Texas Commission on Environmental Quality
Remediation Division Correspondence Identification Form

DOCUMENT(S) IDENTIFICATION	
PHASE OF REMEDIATION	DOCUMENT NAME
1. Miscellaneous	RESPONSE TO TCEQ COMMENT LETTER DATED JULY 16, 2020
2. Please select a phase of remediation	
3. Please select a phase of remediation	
4. Please select a phase of remediation	
5. Please select a phase of remediation

**RE: RESPONSE TO TCEQ COMMENT LETTER DATED JULY 16, 2020
INTERIM GROUNDWATER MONITORING REPORT (2019-2020), DATED APRIL 30, 2020
UNION PACIFIC RAILROAD – HOUSTON WOOD PRESERVING WORKS
HOUSTON, HARRIS COUNTY, TEXAS
HAZARDOUS WASTE PERMIT/ COMPLIANCE PLANE NO: 50343, ISWR NO 31547
EPA ID NO. TXD000820266; RN100674613; CN600131098**

Source: API, 2011

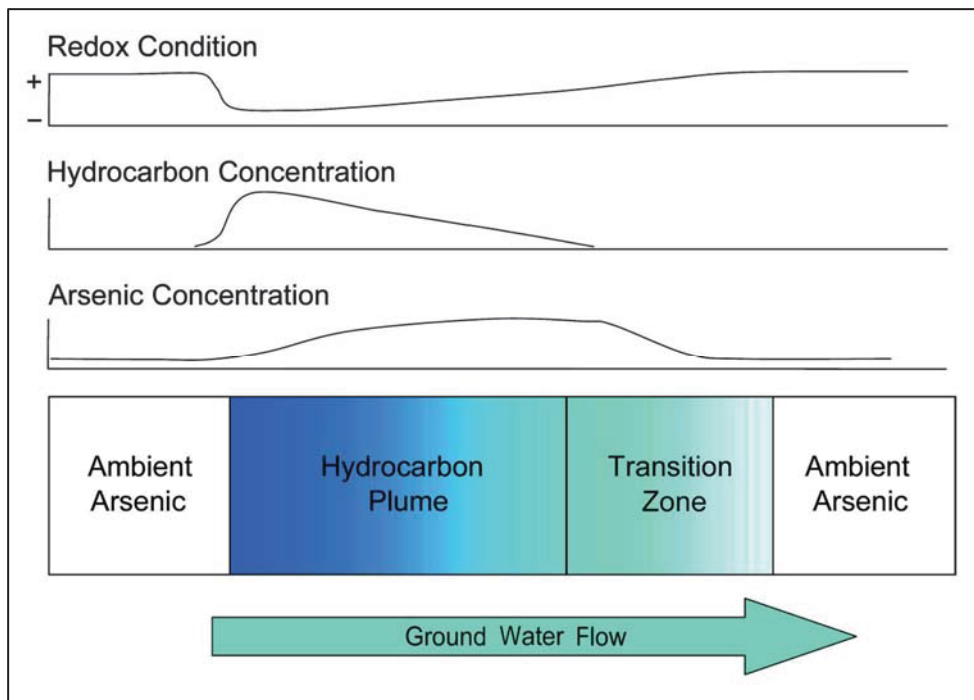
- 1. In the Report, UPRR explains that arsenic concentrations in the A-TZ wells don't appear to correlate with the elevated concentrations of the primary site-specific COCs and are likely associated with naturally-occurring arsenic mobilizing under reducing conditions caused by the natural degradation of petroleum hydrocarbons. However, the Report does not contain any site-specific supporting information to verify that arsenic is naturally occurring. For instance, no site-specific background groundwater concentrations have been established, and there is also no site-specific geochemical data to support a reduced environment. UPRR should provide a more detailed discussion of how arsenic will be further evaluated and if additional wells are proposed to delineate arsenic in the A-TZ and B-CZ/B-TZ.*

The ability of the geochemical environment to enhance the solubility and thus the equilibrium concentration of naturally-occurring arsenic in groundwater is well known and has been detailed in multiple references including the American Petroleum Institute (API) Groundwater Arsenic Manual – Attenuation of Naturally-Occurring Arsenic at Petroleum Impacted Sites (API Manual) (API Publication 4761) (API, 2011). The API Manual describes the process of developing the arsenic-specific site-specific conceptual model (SSCM) for evaluating arsenic in groundwater at petroleum-impacted sites. As described in API Publication 4761, the presence of hydrocarbons perturbs ambient geochemical conditions (typically lowering the oxidation-reduction (redox) potential to more reduced conditions) in groundwater, which may increase the solubility of naturally occurring arsenic in the aquifer matrix. The conceptual model for naturally occurring arsenic dissolution and attenuation at a hydrocarbon plume is summarized in the figure below (taken from Figure 1-5 of API Publication 4761).

Upgradient of the hydrocarbon plume, ambient conditions exist with typically higher (i.e., less reducing) redox potential and background or ambient arsenic concentrations. Within the hydrocarbon plume, hydrocarbon COC concentrations are elevated, which induce reducing conditions (i.e., negative redox), and thereby create a geochemical environment that allows natural arsenic in the aquifer matrix to go into solution resulting in higher concentrations. Downgradient of the hydrocarbon plume, within the “transition zone” where hydrocarbon COC

concentrations degrade to near background conditions, arsenic concentrations may continue to be slightly elevated due to this localized redox shift before decreasing to background arsenic concentrations where groundwater reaches ambient conditions.
